WILLIAMSON COUNTY, TEXAS

CHANGE ORDER NUMBER: 1

Project: 23IFB6

Roadway: CR 404 at FM 973

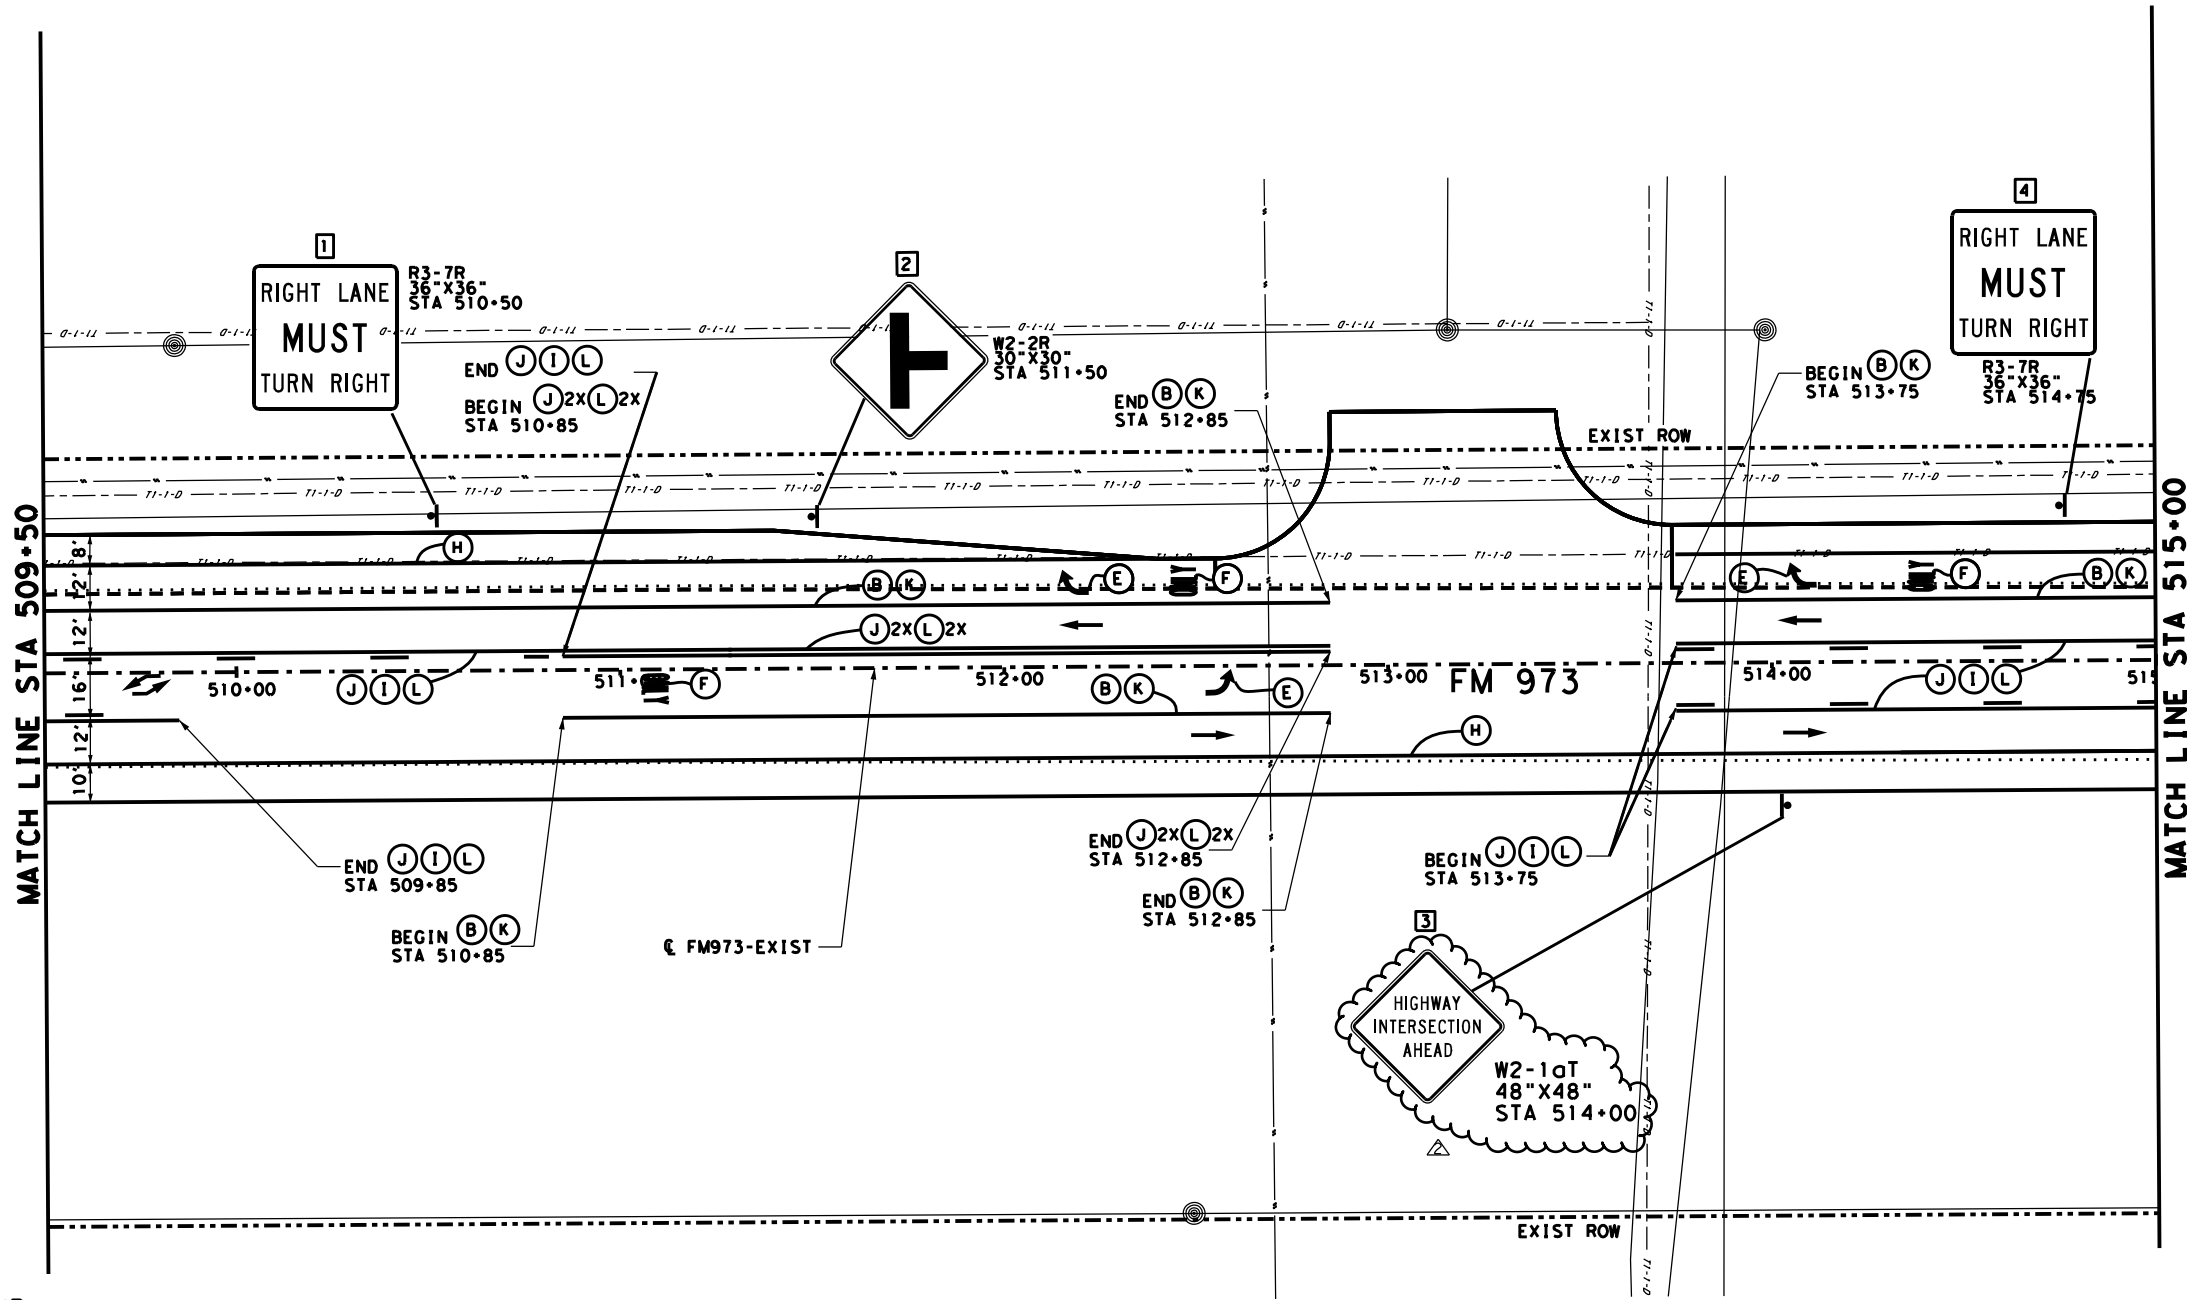
NO.	REVISIONS	BY	DATE
	SAMSUNG DRIVEWAY REVISIONS	RK	12/2/22
	ADD RUMBLE STRIPS	RK	5/12/23

SIGNALS AND CR 404/FM 973
SIGNING AND
PAVEMENT MARKINGS
SHEET 16 OF 16

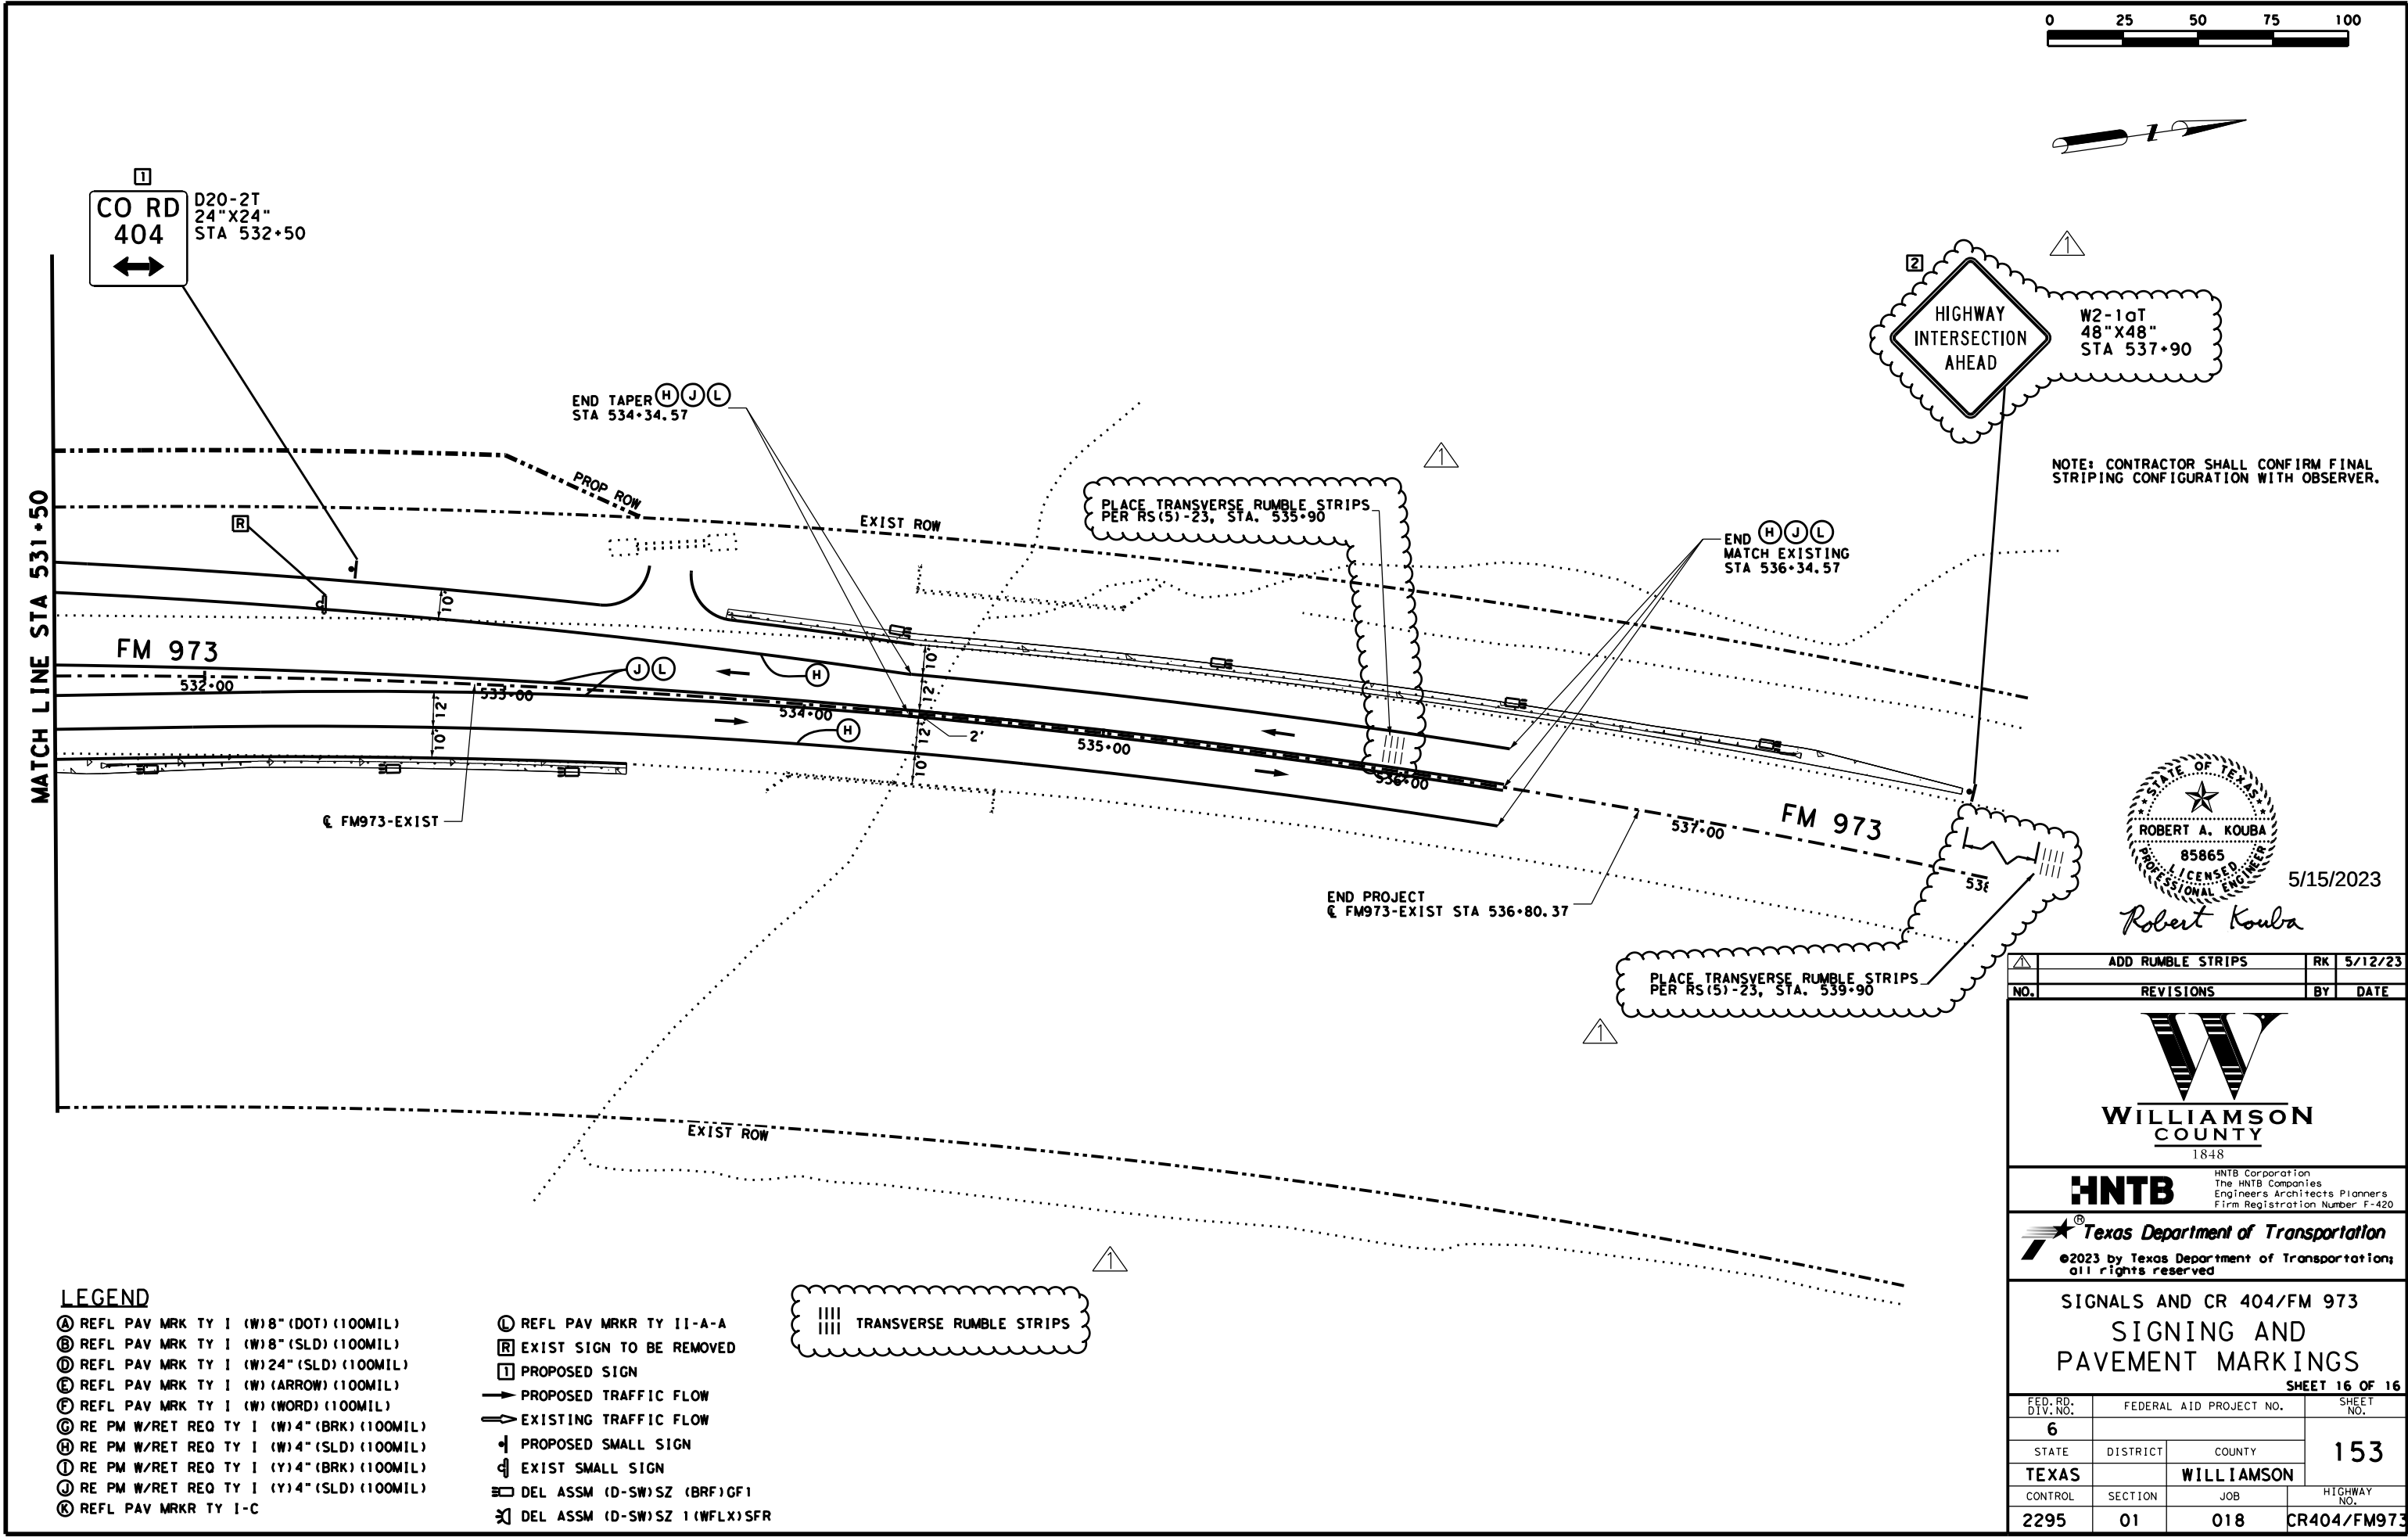
ADD RUMBLE STRIPS		RK	5/12/23
NO.	REVISIONS	BY	DATE

TRANSVERSE OR IN-LANE RUMBLE STRIPS

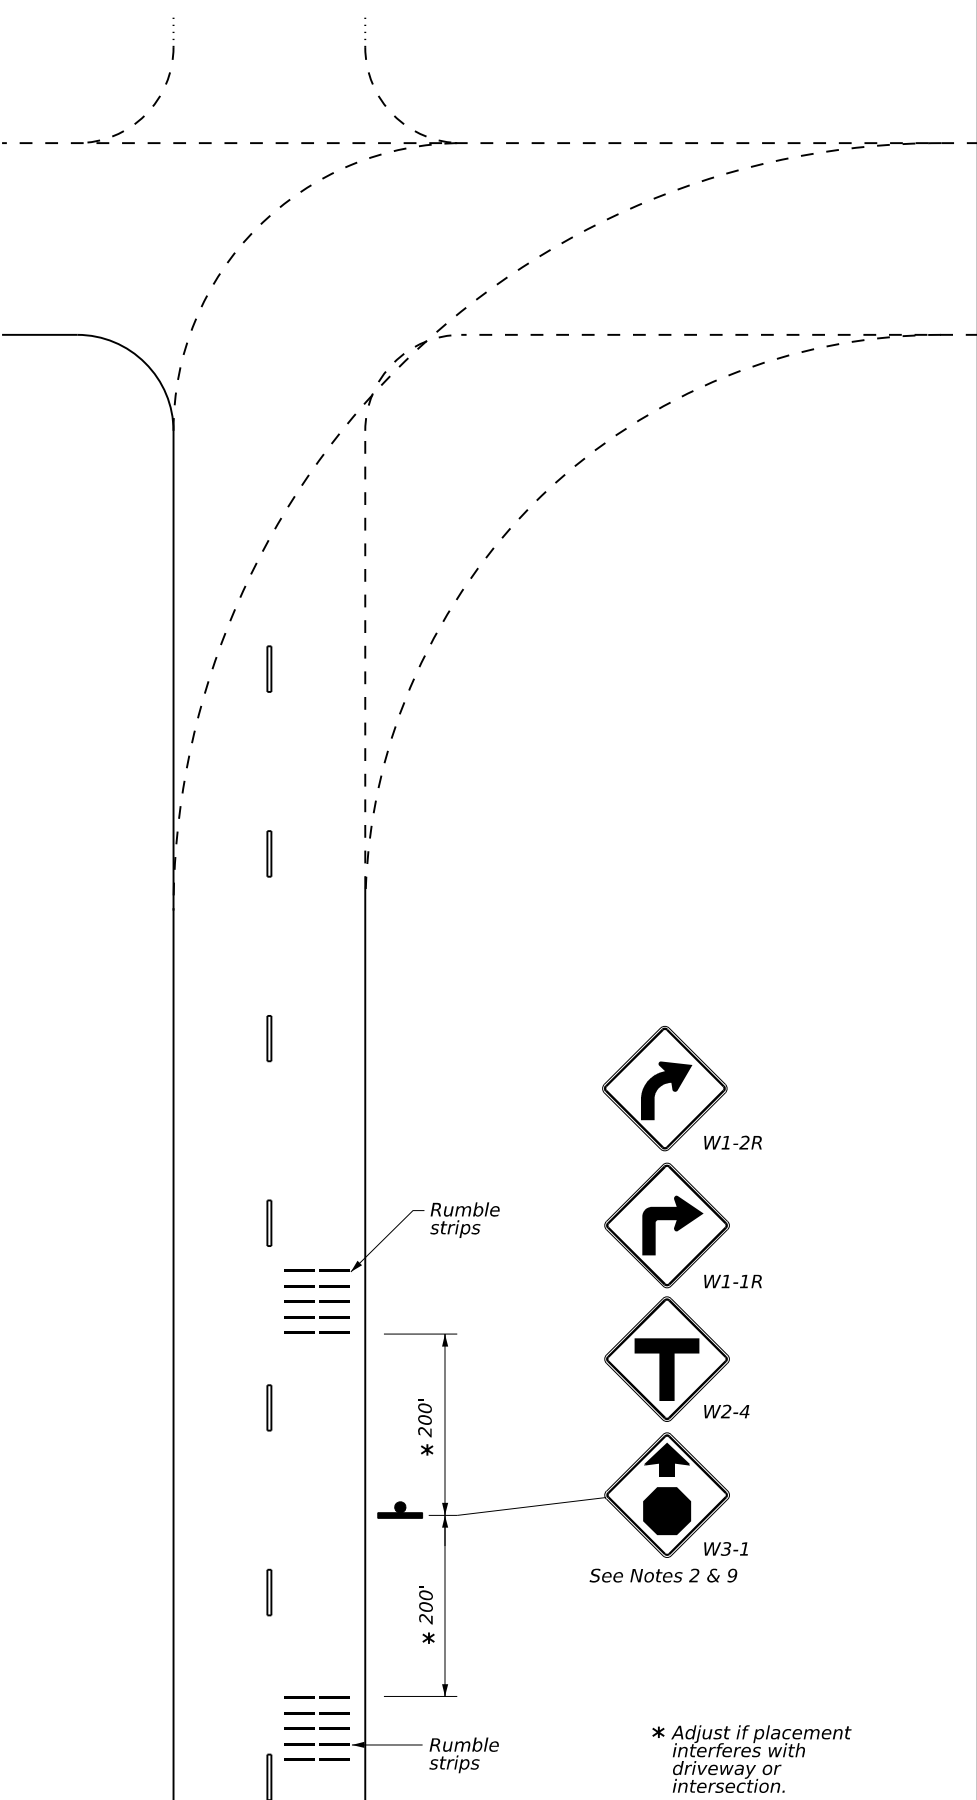
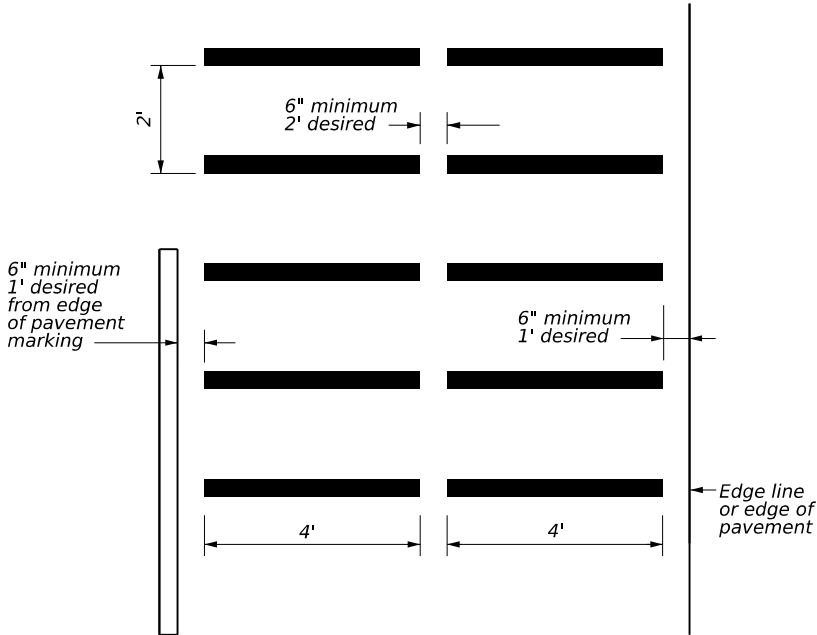
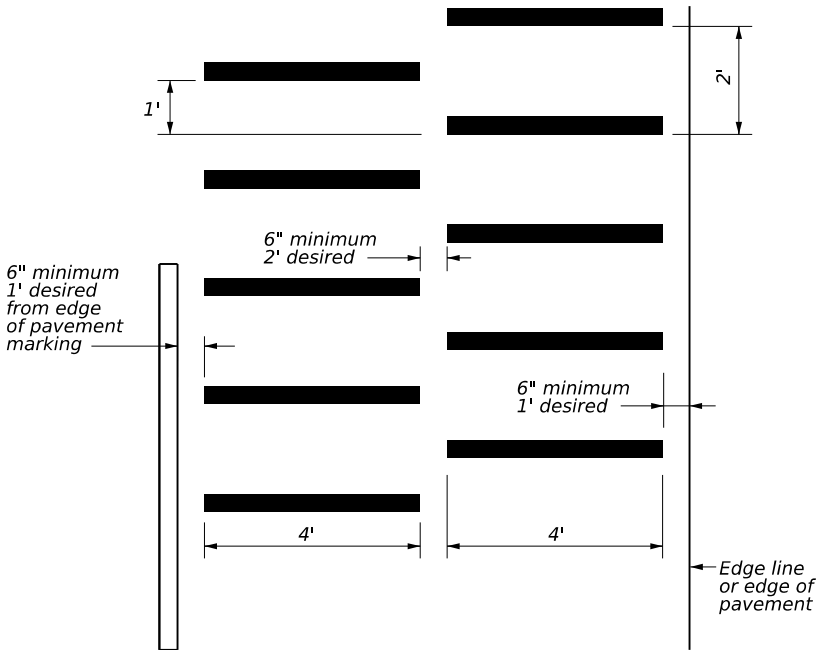
- Rumble strips were added at the request of Williamson County to bring awareness to the new traffic signals.
- Flexible pavement repair was needed due to asphalt failures in the existing FM 973 roadway.

2. When used, the rumble strips shall be placed 200 feet upstream and downstream of the warning sign.
3. The use of rumble strips should not be widespread or indiscriminate.
